SHEPHERD SUBSTATION PROJECT

Minor Project Change Request Form

Proposed Minor Project Change Type:	Request #:
Minor Project Modification (MPM)	5

Photo 1: Proposed Large Pull and Tension Site

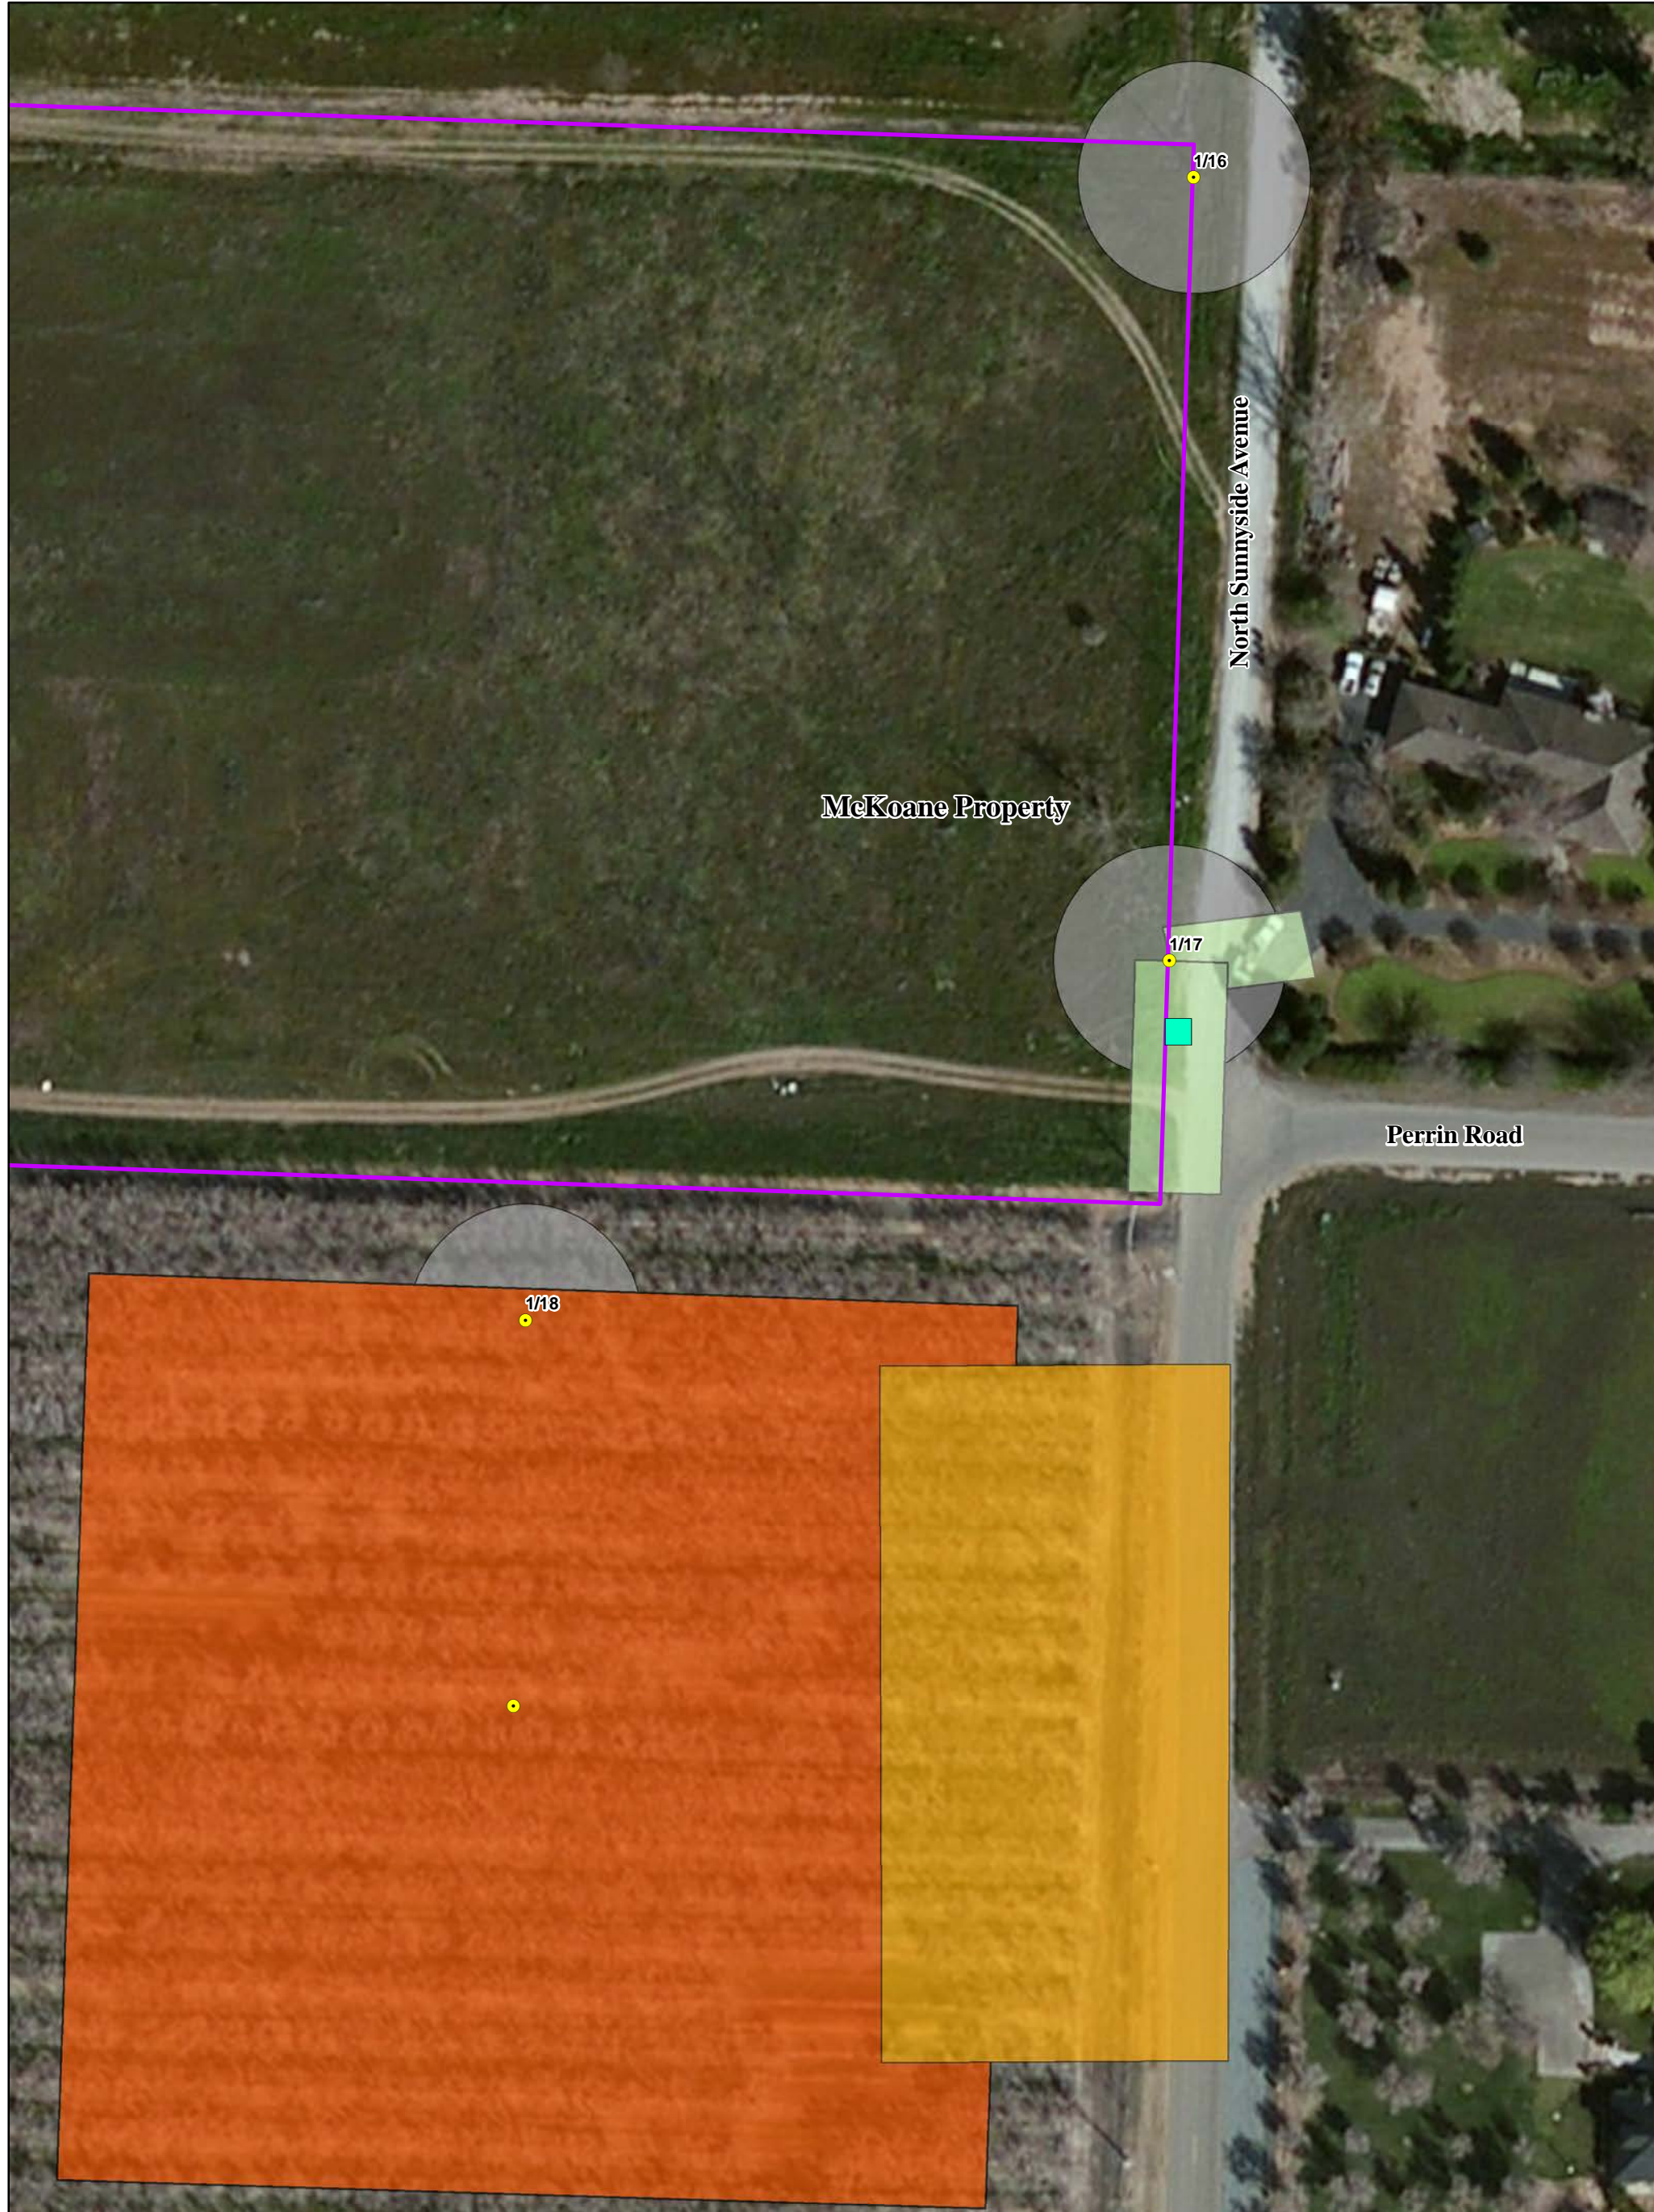
<p>1) PG&E requires the use of two additional pull and tension sites (PTS), located nearly entirely on the paved road portion and disturbed road shoulders of North Sunnyside Avenue, near proposed tubular steel pole (TSP) 1/17. The dimensions of the large PTS will be 40 feet by 100 feet. The westerly 15 feet fall within private property (McKoane; APN 556-040-23S). A significant portion of the total workspace for this PTS falls within the currently approved 50-foot project workspace, thus, PG&E is requesting to utilize the space that is beyond the permitted area. The dimensions of the smaller PTS will be 30 feet by 60 feet. Activities within the smaller PTS will be conducted entirely on the road and road shoulder. This PTS also falls almost entirely with the current 50-foot workspace. Road and/or lane closures on North Sunnyside and/or Perrin Road would be accompanied by the necessary traffic plans and submitted ahead of activity; all necessary land rights have been acquired. In summary, these two proposed PTS would result in 2,400 square feet of new temporary disturbance outside of the currently permitted workspace.</p> <p>The installation of gravel, rock, or similar all-weather material (e.g., steel plates and rubber mats) may be necessary to stabilize the westerly edge of the larger PTS (i.e., those portions falling on private property and road shoulder). At this time, applying a base is not required; however, PG&E is requesting the approval to install this material should weather conditions and/or equipment weight require it. If a base is installed, a fabric liner will be installed prior to material application to assist with removal; imported material will not be left onsite.</p>

The installation of base material is anticipated to take 2-3 days, totaling an estimated increase of 4 dump truck trips delivering approximately 40 cubic yards of material. Removal would require the same level of effort. The existing "T-post" and barbed wire fence would be removed along the 100-foot section of the larger PTS and replaced at the conclusion of activity. The rock and fabric placement is a newly proposed activity at this location.

1) The previously permitted location of the southern project PTS (transmission line component), located at the northeast corner of the substation lot, is no longer a safe and feasible location to conduct pull and tension activities. The location of adjacent overhead power lines, specifically the re-routed location of the 12 kV project shoo-fly line and associated poles, do not provide sufficient clearance from the conductor sag and tensioning anticipated during wire stringing. Adjusting the location of the PTS northward to the proposed location situates the equipment beyond the conflicting power lines and avoids many potential safety hazards.
